ADDENDUM NO. [1]

Date: January 30, 2020

**RE: SOUTHWEST WISCONSIN TECHNICAL COLLEGE
PLATTEVILLE OUTREACH CENTER
75 SOUTH OAK ST
PLATTEVILLE, WI
BID NUMBER: 1920-07**

**FROM: HSR Associates, Inc
100 Milwaukee Street
La Crosse, WI 54603
(608) 784-1830**

1 FIRST FLOOR REMODEL PLAN
1/4" = 1'-0"

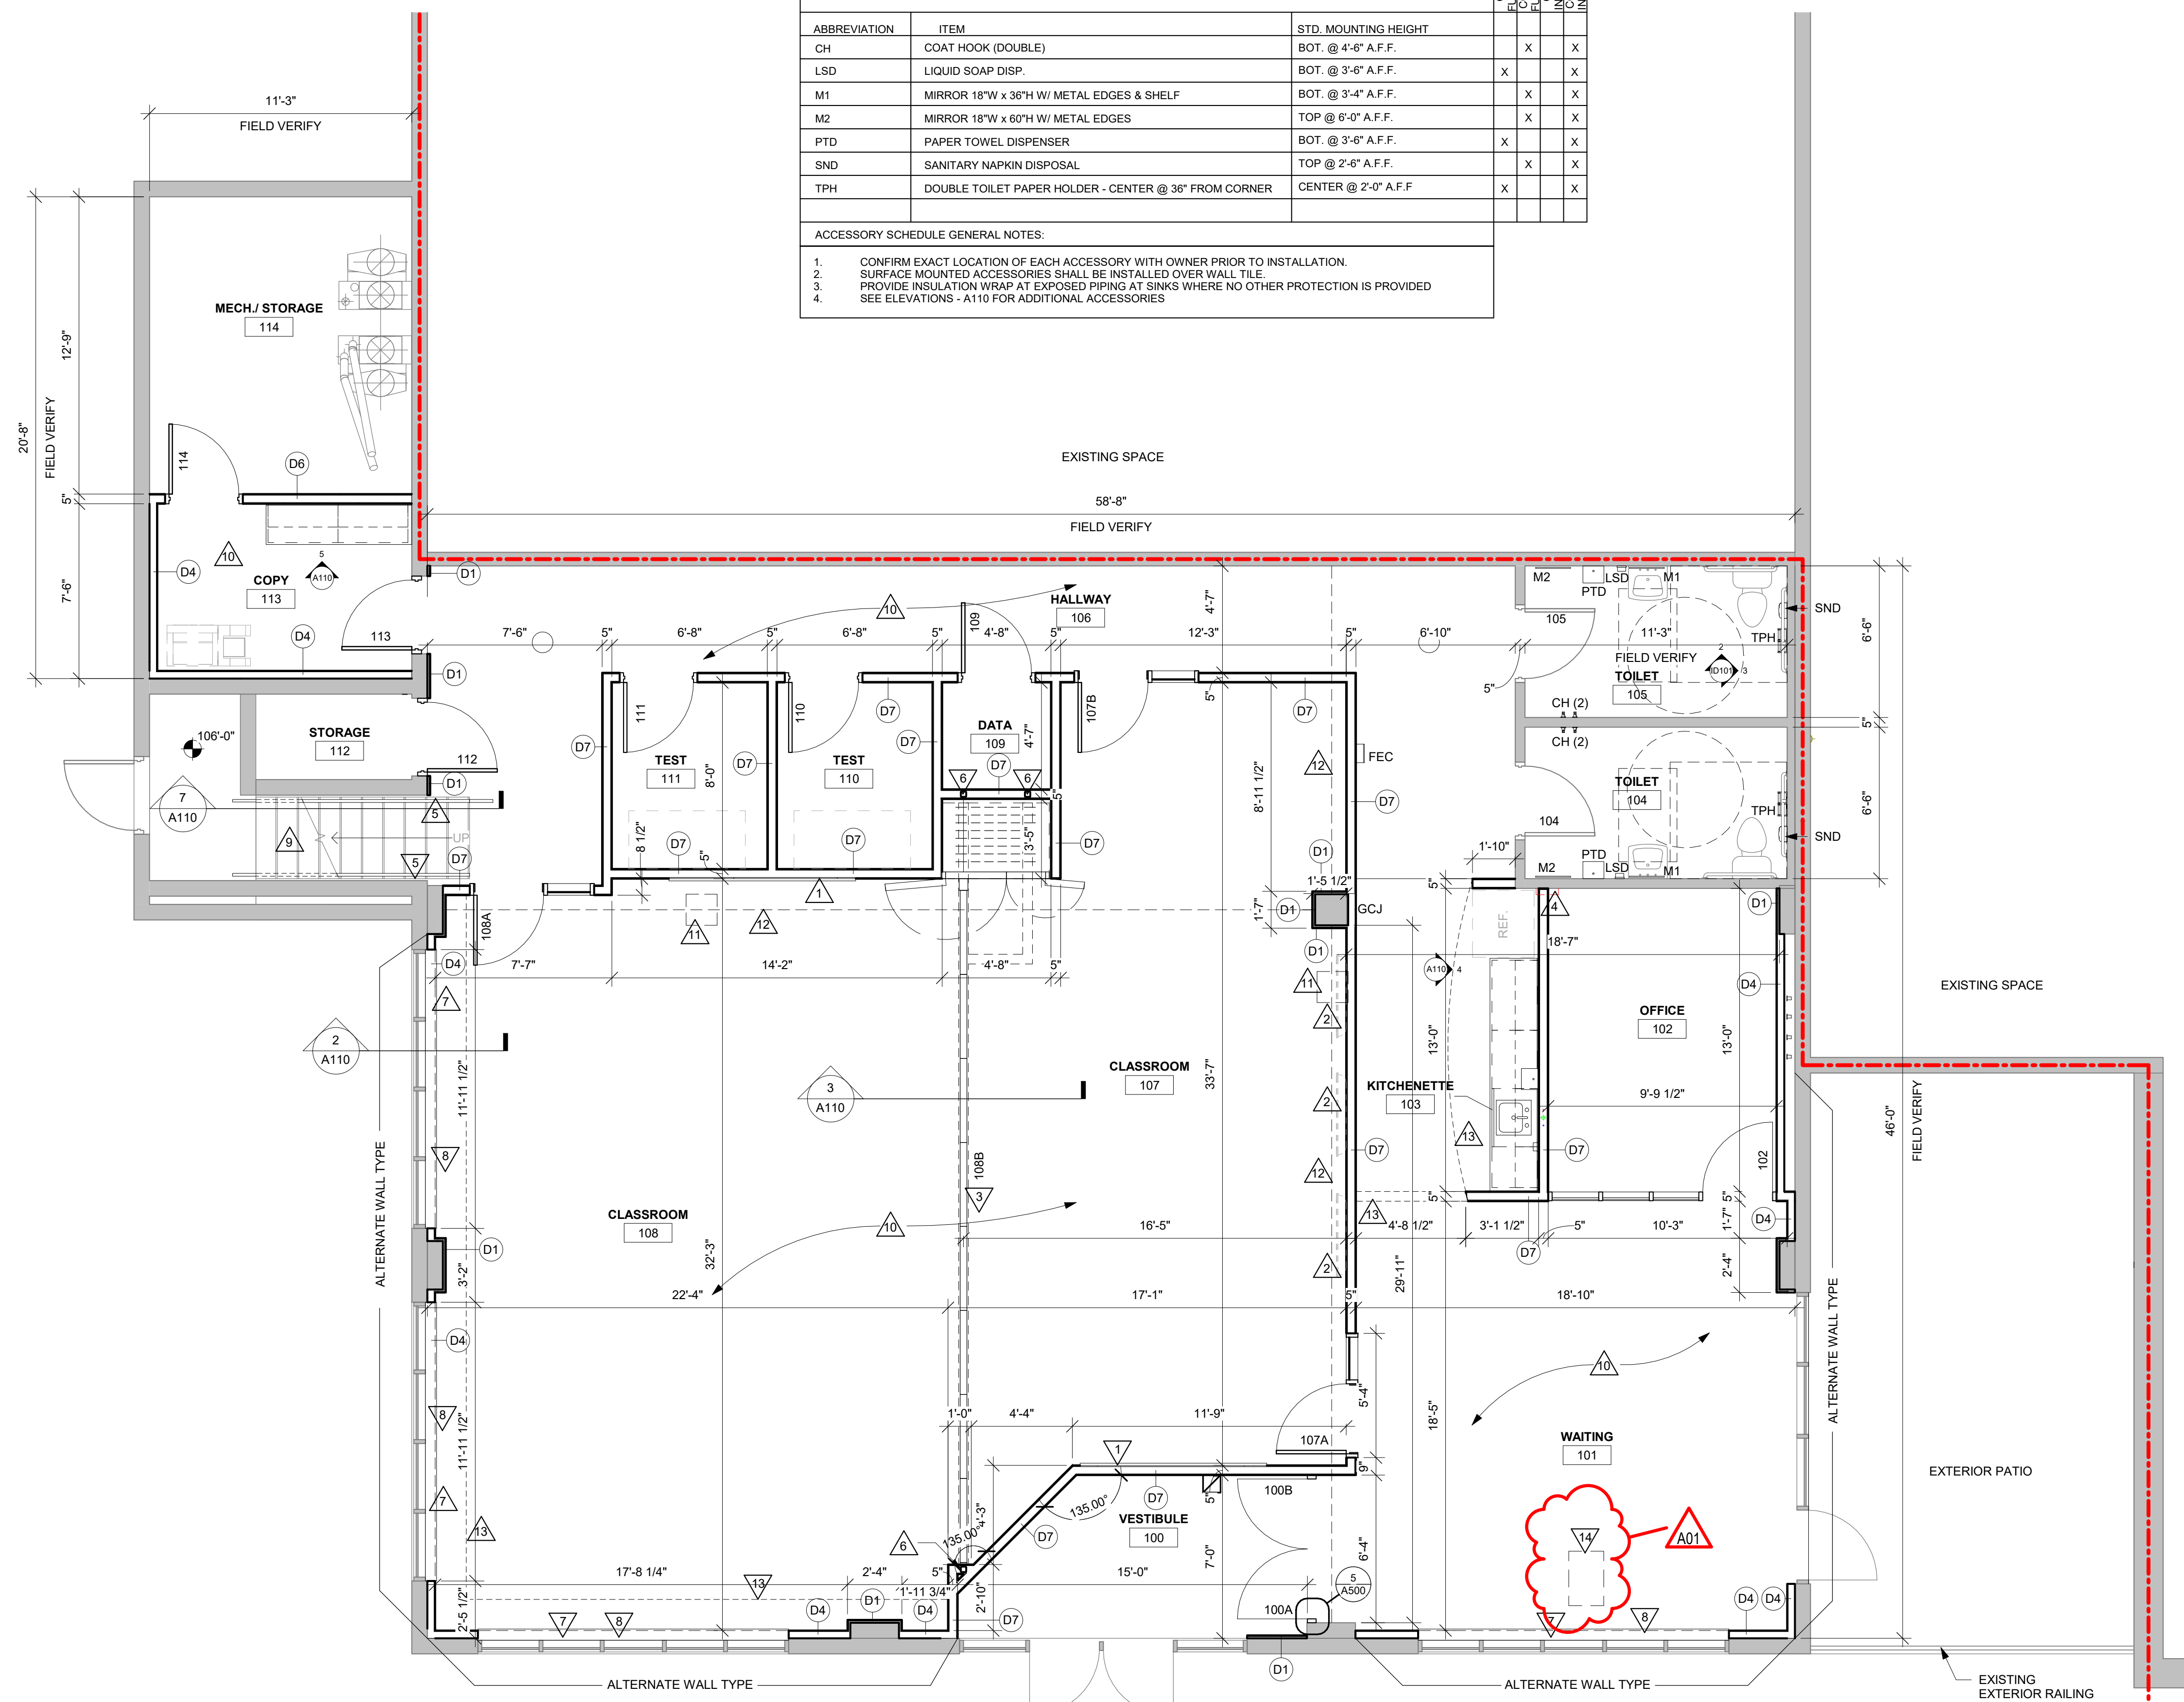
10. Sheet A100 FIRST FLOOR REMODEL PLAN 30 x 42 attached hereto
 - a. Revisions clouded on Drawing.
11. Sheet A110 RCP, SECTIONS AND CASEWORK ELEVATIONS 30 x 42 attached hereto
 - a. Revisions clouded on Drawing.
12. Sheet A500 STEEL BEAM PLAN AND DETAILS 30 x 42 attached hereto
 - a. Revisions clouded on Drawing.
13. Sheet ID101 FINISH FLOOR PLAN
 - a. The upper landing of the west stair is identified to receive walk-off carpet.
 - b. Note 1 at upper landing indicates paint for the stair area walls.
14. Sheet E200 POWER PLAN 30 x 42 attached hereto
 - a. Revisions clouded on Drawing

- A. Alternate No. 1: Wall Insulation
 - 1. The following work shall be priced under Alternate No. 1: State the amount to be added to the base bid to add rigid insulation to exterior wall as shown on Sheet A100.
